EQUIPMENT/FURNISHINGS - RH REFRESHMENT CENTER AND LH FORWARD CABINET REINFORCEMENTS INSTALLATION

Structural analysis with RH Refreshment center and LH forward cabinet indicates the need for new reinforcements installation.

To install reinforcements on the RH refreshment center and LH forward cabinet, and to replace rivets of the floor support of the RH Refreshment Center.

FIGURE 1 - LH FORWARD CABINET - REWORK - GROUPS 1 AND 2
(Sheet 2 of 2)

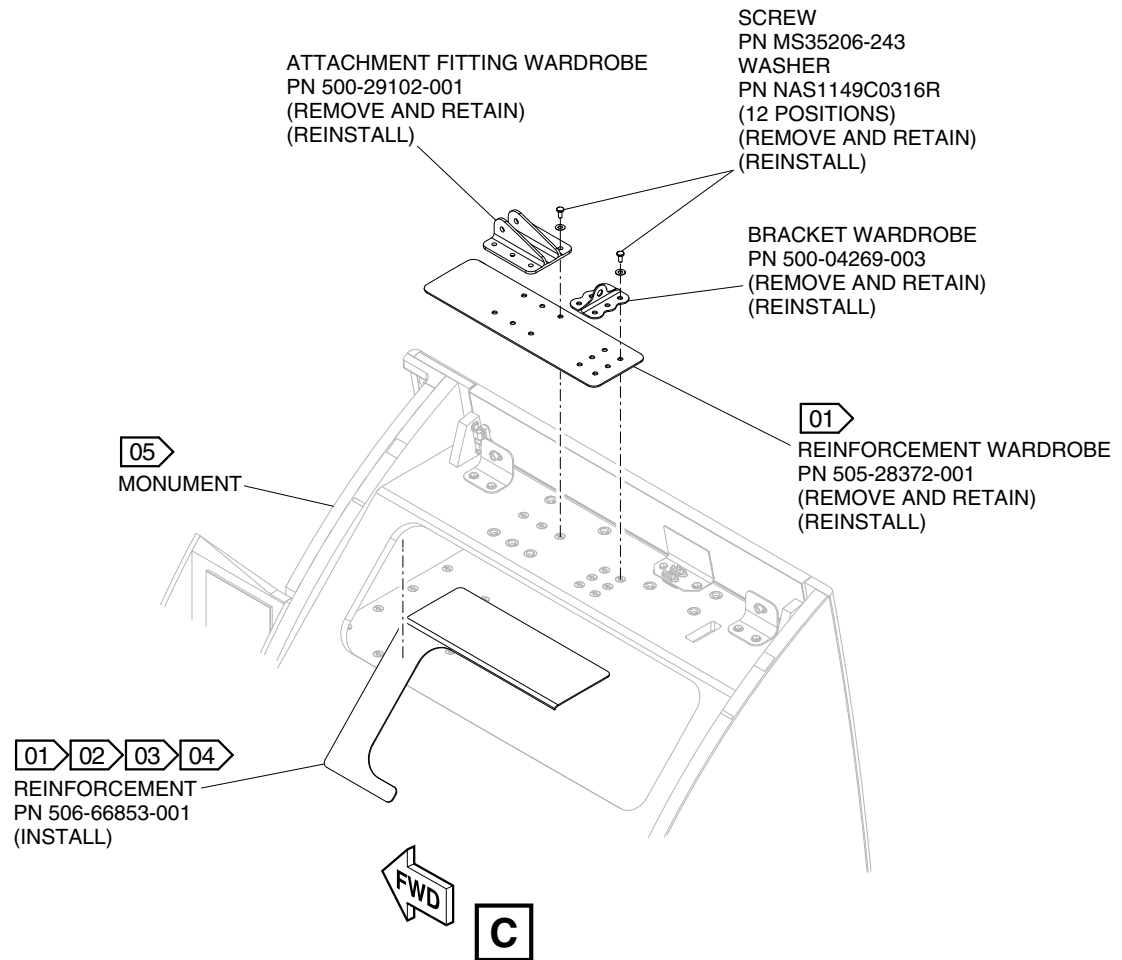
- (10) Remove the LH forward cabinet. Refer to [AMM TASK 25-26-01-000-801-A/400](#) - LH Forward Cabinet - Removal.
- (11) Rework the LH forward cabinet according to instructions given in [Figure 1](#).

FIGURE 2 - RH REFRESHMENT CENTER - REINFORCEMENT INSTALLATION - GROUPS 1 AND 2
(Sheet 1 of 2)

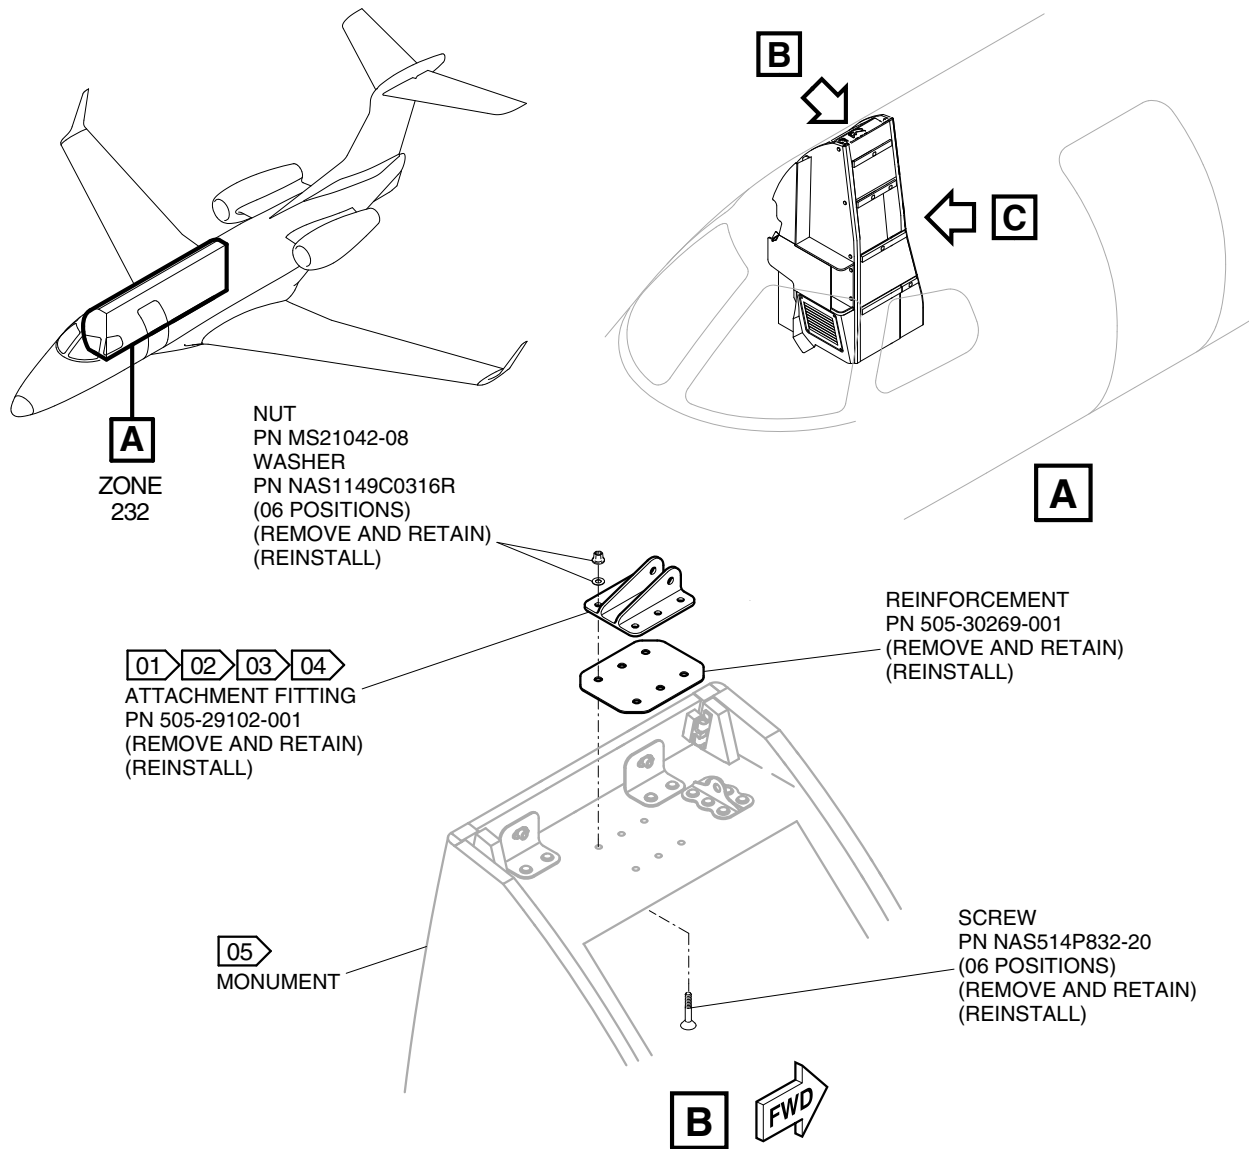
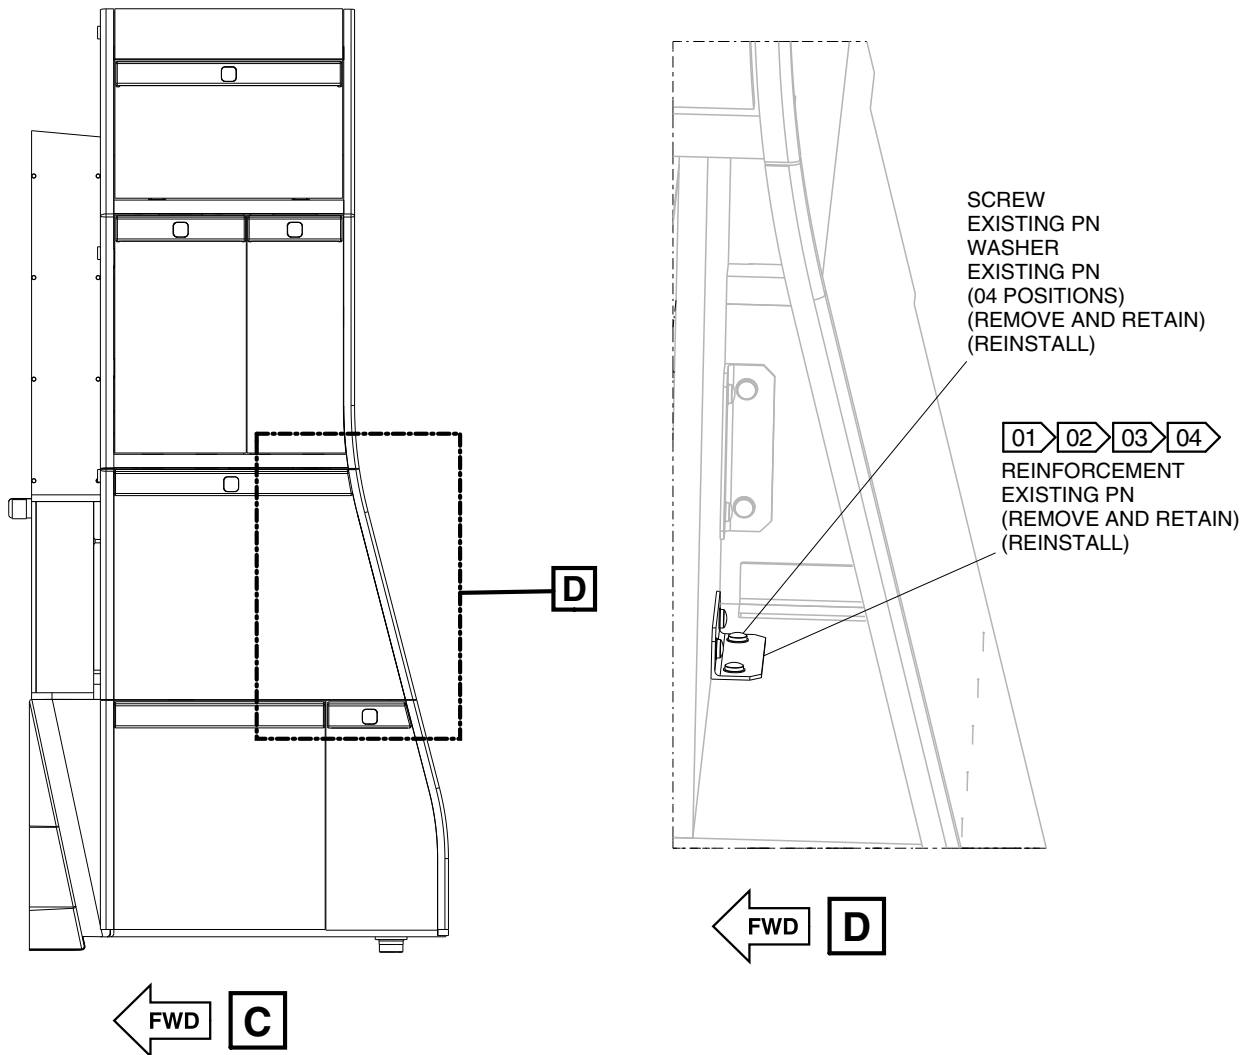
- (12) Remove the RH Refreshment Center. Refer to [AMM TASK 25-31-02-000-801-A/400](#) - RH Refreshment Center - Removal.
- (13) Rework the RH Refreshment Center according to instructions given in [Figure 2](#) and [Figure 3](#).

- 01 APPLY ADHESIVE EC-460
- 02 MANUALLY SAND PANEL AREA WHERE ADHESIVE IS TO BE APPLIED USING SANDPAPER GRIT 80 IN TWO PERPENDICULAR DIRECTIONS TO BREAK THE GLOSS AND SCRATCH THE SURFACE. CLEAN PANEL BEFORE AND AFTER SANDING PROCESS USING A CLOTH DAMPENED WITH ISOPROPYL ALCOHOL
- 03 MANUALLY SAND SURFACE OF METAL DOUBLERS AND BRACKETS TO BE BONDED TO PANELS USING ADHESIVE. SAND IN TWO PERPENDICULAR DIRECTIONS TO AID BONDING. CLEAN METAL SURFACE BEFORE AND AFTER SANDING PROCESS USING A CLOTH DAMPENED WITH ISOPROPYL ALCOHOL
- 04 USE TAPE TO HOLD BONDED ITEMS IN PLACE DURING TIME TAKEN FOR ADHESIVE TO CURE
- 05 USE PERMANENT INK MARKER TO REIDENTIFY MONUMENT

- 01 APPLY ADHESIVE EC-460
- 02 MANUALLY SAND PANEL AREA WHERE ADHESIVE IS TO BE APPLIED USING SANDPAPER GRIT 80 IN TWO PERPENDICULAR DIRECTIONS TO BREAK THE GLOSS AND SCRATCH THE SURFACE. CLEAN PANEL BEFORE AND AFTER SANDING PROCESS USING A CLOTH DAMPENED WITH ISOPROPYL ALCOHOL
- 03 MANUALLY SAND SURFACE OF METAL DOUBLERS AND BRACKETS TO BE BONDED TO PANELS USING ADHESIVE. SAND IN TWO PERPENDICULAR DIRECTIONS TO AID BONDING. CLEAN METAL SURFACE BEFORE AND AFTER SANDING PROCESS USING A CLOTH DAMPENED WITH ISOPROPYL ALCOHOL
- 04 USE TAPE TO HOLD BONDED ITEMS IN PLACE DURING TIME TAKEN FOR ADHESIVE TO CURE

FIGURE 4 - RH REFRESHMENT CENTER - REWORK - GROUPS 3, 4, 5, 6, 8, AND 10
(Sheet 2 of 3)

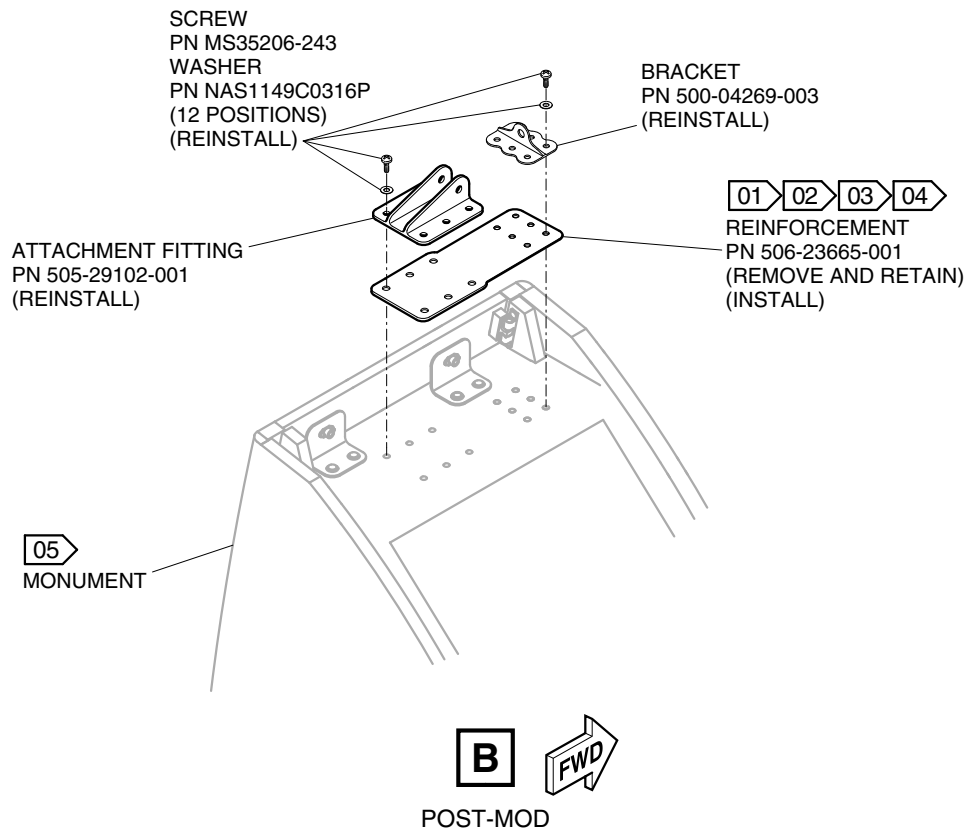
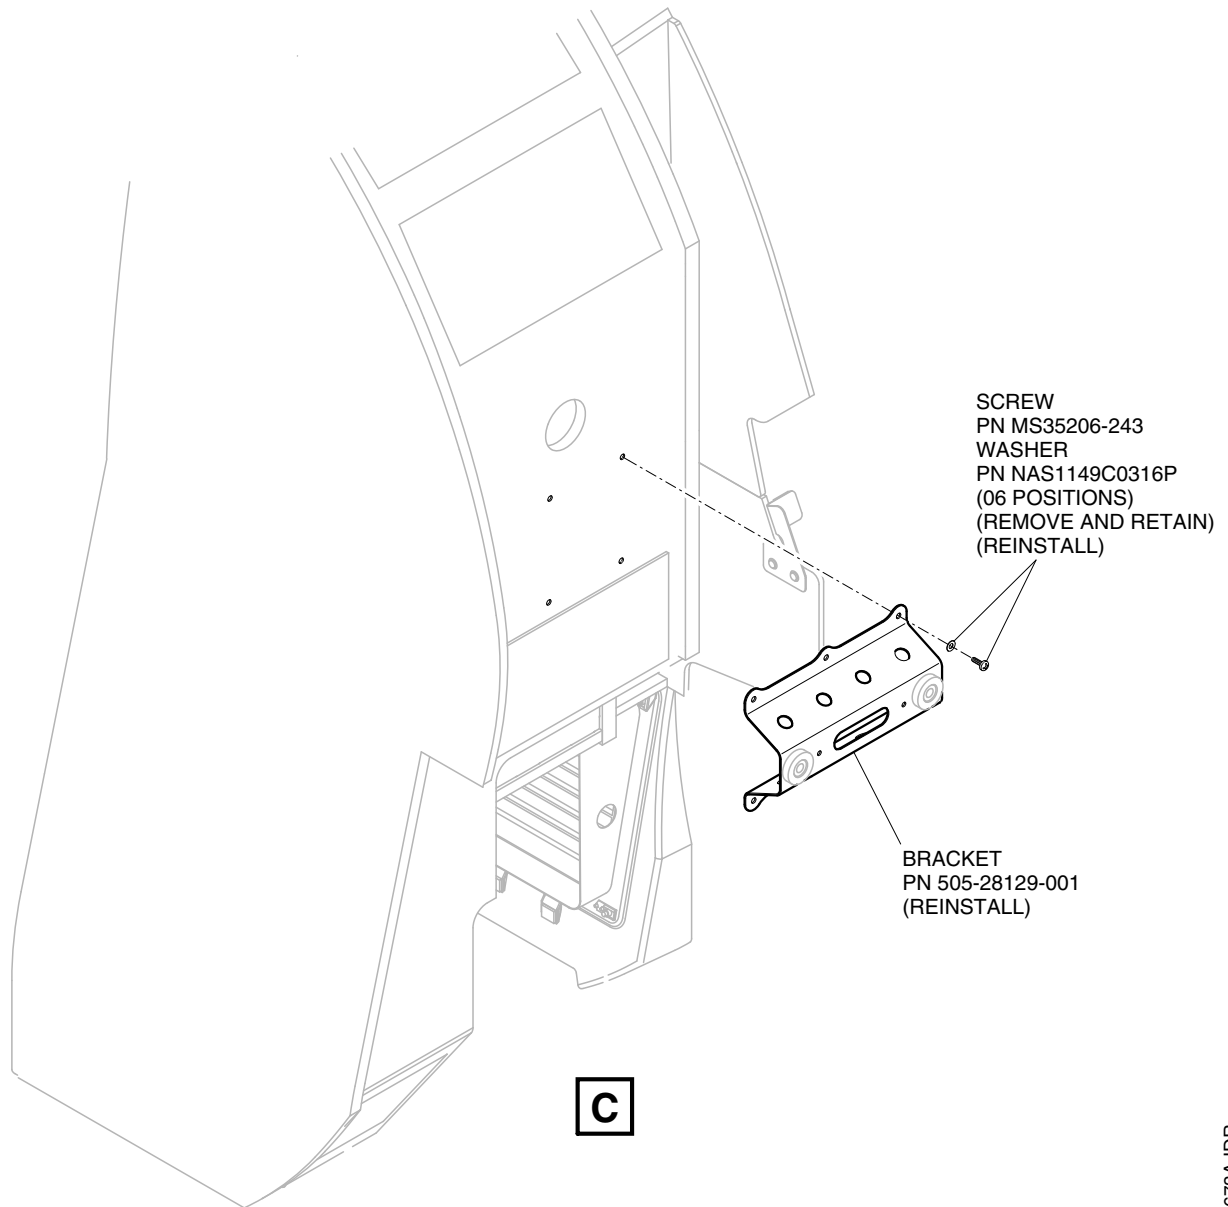
- (13) Rework the RH Refreshment Center according to instructions given in [Figure 4](#).
- (14) Replace rivets at frame 8A according to instructions given in [Figure 5](#).

- 01 APPLY ADHESIVE EC-460
- 02 MANUALLY SAND PANEL AREA WHERE ADHESIVE IS TO BE APPLIED USING SANDPAPER GRIT 80 IN TWO PERPENDICULAR DIRECTIONS TO BREAK THE GLOSS AND SCRATCH THE SURFACE. CLEAN PANEL BEFORE AND AFTER SANDING PROCESS USING A CLOTH DAMPENED WITH ISOPROPYL ALCOHOL
- 03 MANUALLY SAND SURFACE OF METAL DOUBLERS AND BRACKETS TO BE BONDED TO PANELS USING ADHESIVE. SAND IN TWO PERPENDICULAR DIRECTIONS TO AID BONDING. CLEAN METAL SURFACE BEFORE AND AFTER SANDING PROCESS USING A CLOTH DAMPENED WITH ISOPROPYL ALCOHOL
- 04 USE TAPE TO HOLD BONDED ITEMS IN PLACE DURING TIME TAKEN FOR ADHESIVE TO CURE
- 05 USE PERMANENT INK MARKER TO REIDENTIFY MONUMENT

FIGURE 5 - RIVETS REPLACEMENT - FRAME 8A - GROUPS 3, 4, 5, 6, 8, AND 10
(Sheet 1 of 2)

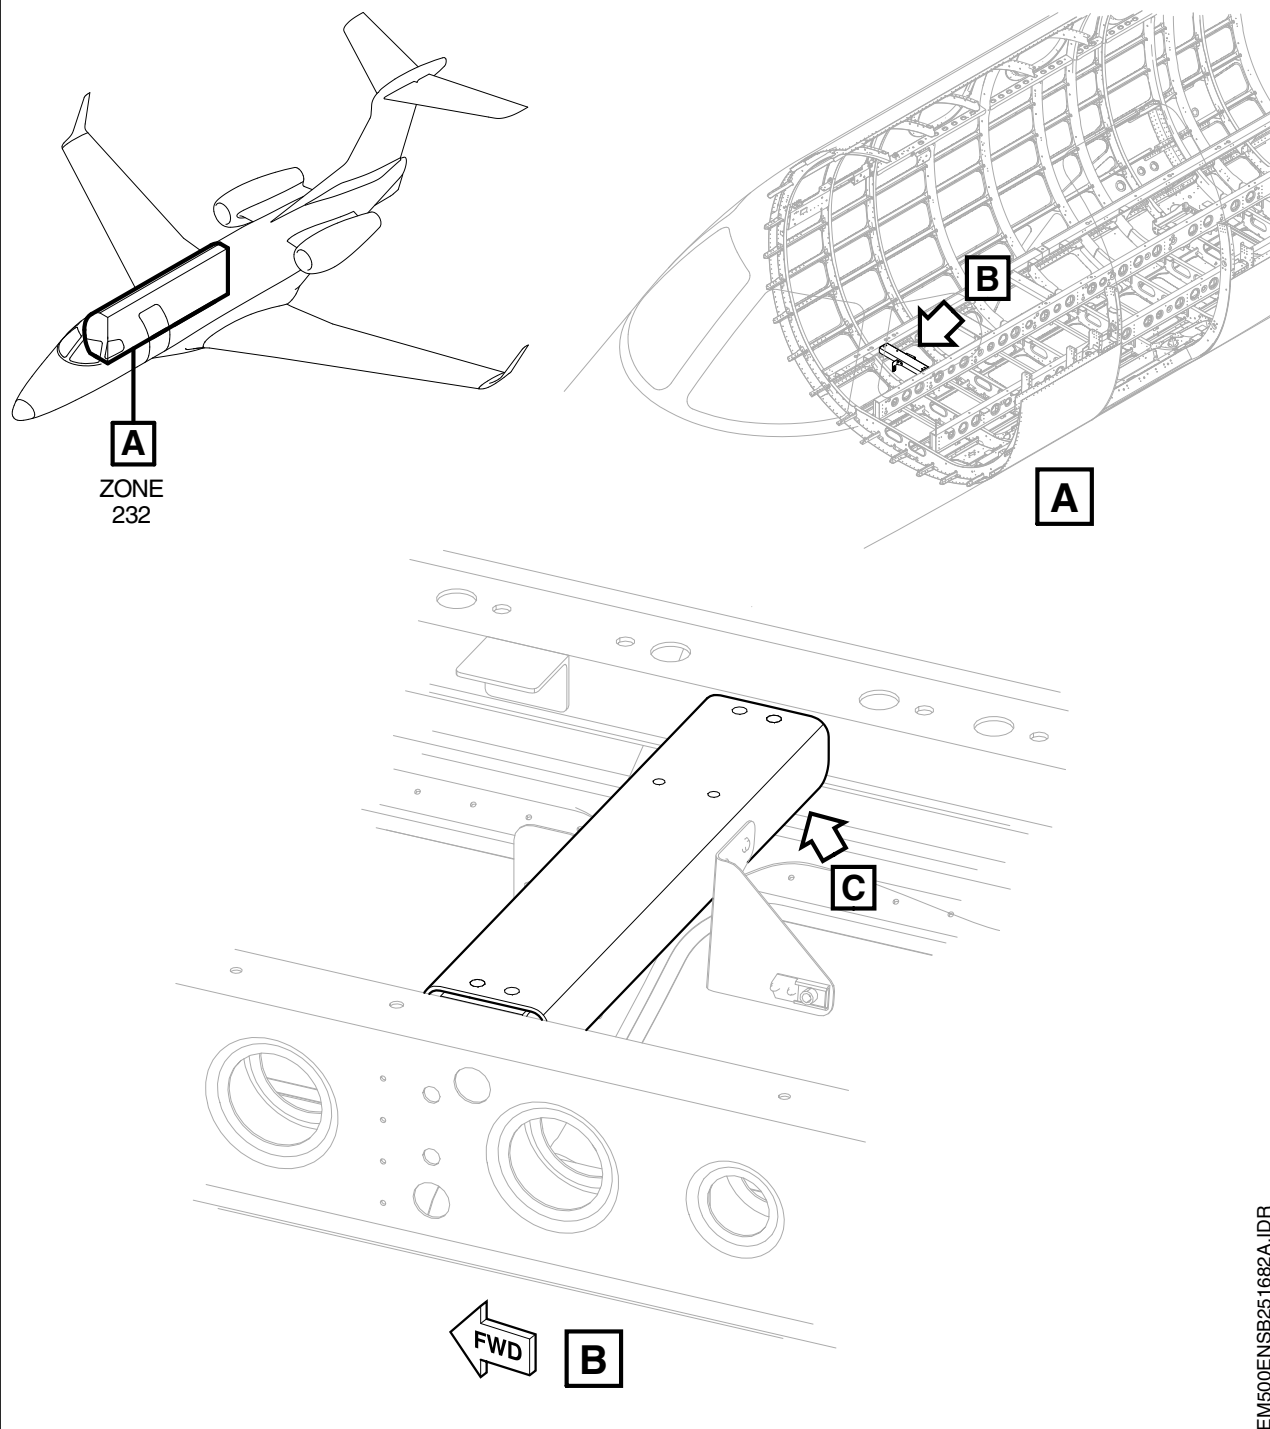
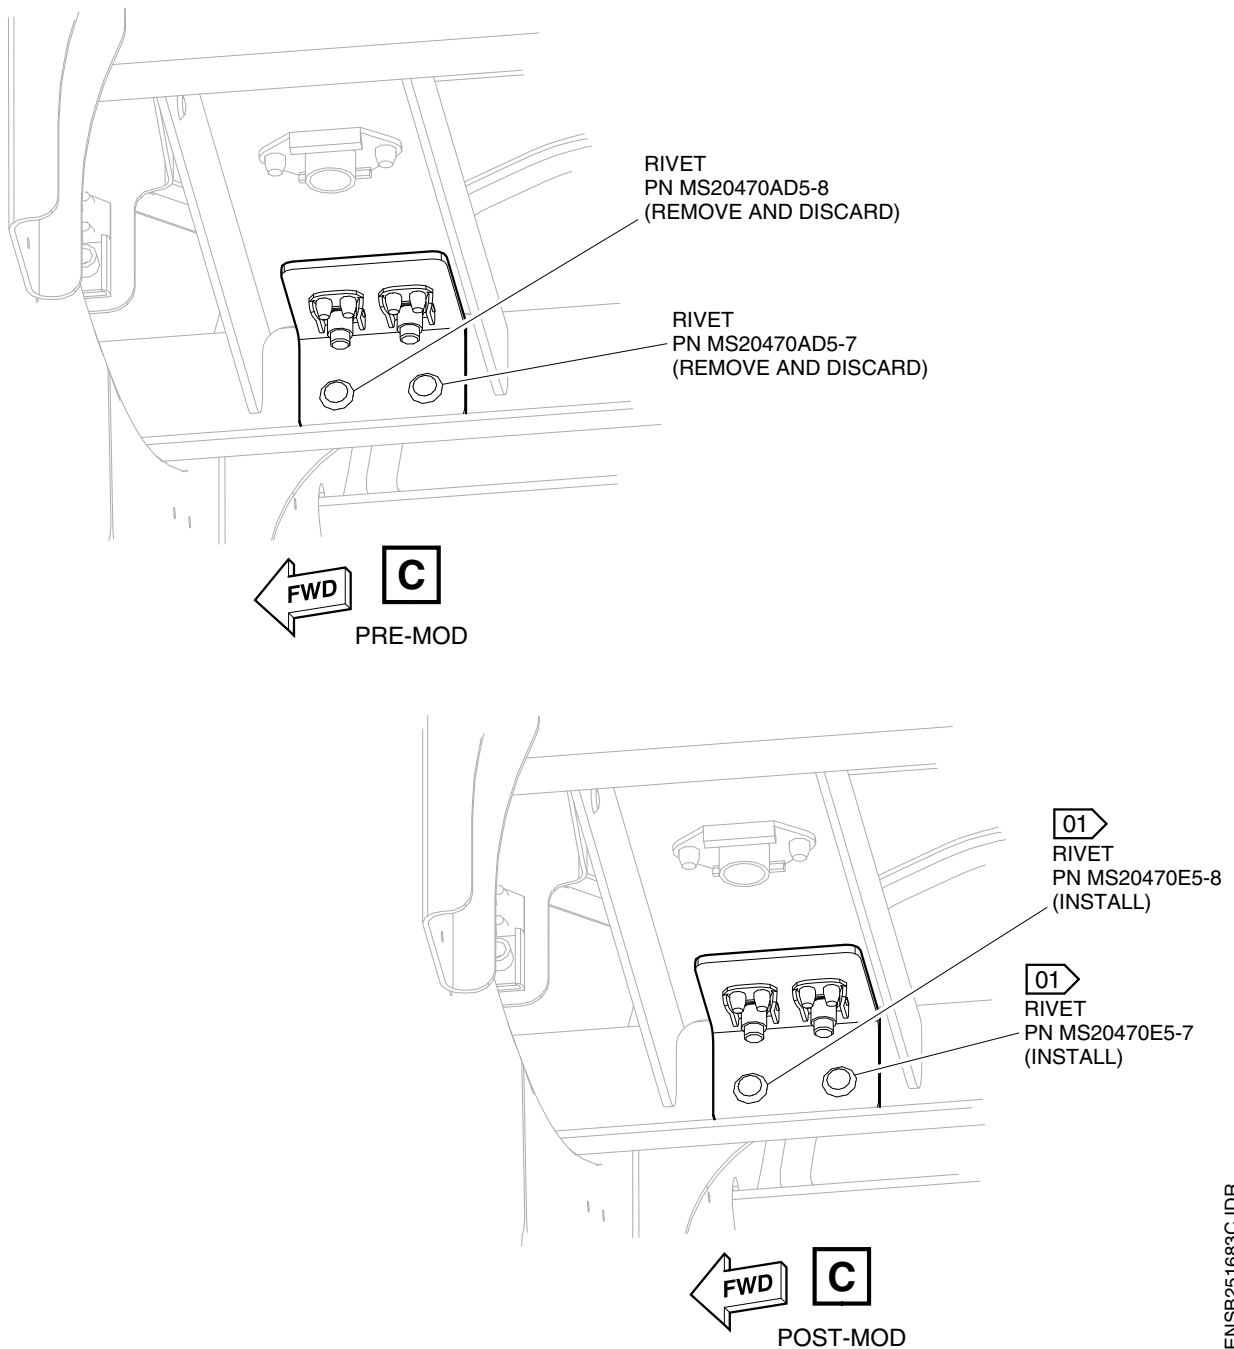
- This revision is being issued to update [Figure 5](#) rivet removal part number.

01 APPLY PN NAFTOSEAL MC780 C-12. SEE SRM 51-21-05.
